UNITED STATES DEPARTMENT OF COMMERCE
Patent and Trademark Office

09/537,274 03/29/00 MOSLEY

| Office Action Summary | Application No. 09/537,274 | Applicant(s) MOSLEY, LARRY EUGENE | |

DETAILED ACTION**Introduction:**

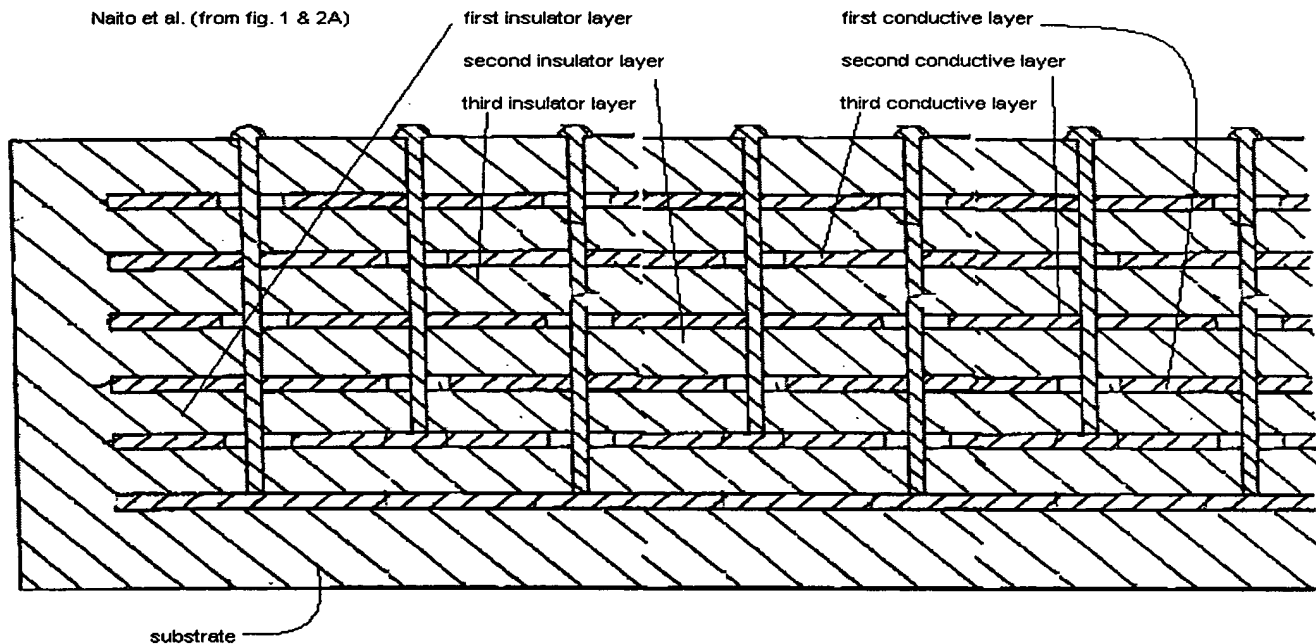
Regarding claim 1, Farooq et al. disclose in fig. 3C, a multilayer integrated circuit capacitor comprising: a substrate¹ (72); a first conductive layer (68) located over the substrate; a first insulator layer (72) located over the first conductive layer; a second conductive layer (67) located over the first insulator layer; a second insulator layer (72) located over the second conductive layer; a third conductive layer (68) located over the second insulator layer; a third insulator layer (72) located over the third conductor layer; and a plurality of conductive vias (64, 66) downwardly extending through the third insulator layer to provide electrical interconnection to the first, second and third conductor layers.

Regarding claim 14, Farooq et al. disclose in fig. 1, & 3C, a circuit board (col. 2 lines 1-7) having supply voltage interconnect (col. 3 lines 3-12) lines; a first integrated circuit die mounted on a circuit package (see fig. 1) a second integrated die mounted on the circuit and electrically connected to the supply voltage interconnect lines, the second integrated circuit package comprises a capacitor comprising: a substrate (72); a first conductive layer (68) located over the substrate; a first insulator layer (72) located over the first conductive layer; a second conductive layer (67) located over the first insulator layer; a second insulator layer (72) located over the second conductive layer; a third conductive layer (68) located over the second insulator layer; a third insulator layer

(72) located over the third conductor layer; and a plurality of conductive vias (64, 66) downwardly extending through the third insulator layer to provide electrical interconnection to the first, second and third conductor layers.

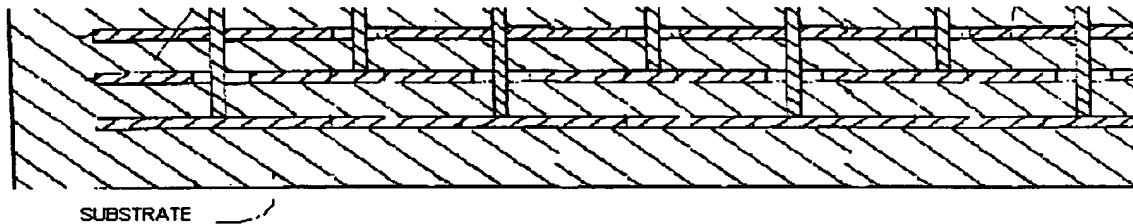
A) The argument "in the Office action, it is also asserted that Naito et al. discloses a substrate. However, Fig. 1 of Naito et al. only recites and illustrates element 32, described as a dielectric material layer". Such a continuous dielectric layer is not the same as a substrate, upon which dielectric material and conductive material maybe formed" is not persuasive. Naito et al. clearly illustrates an underlying layer (substrate see fig. below)
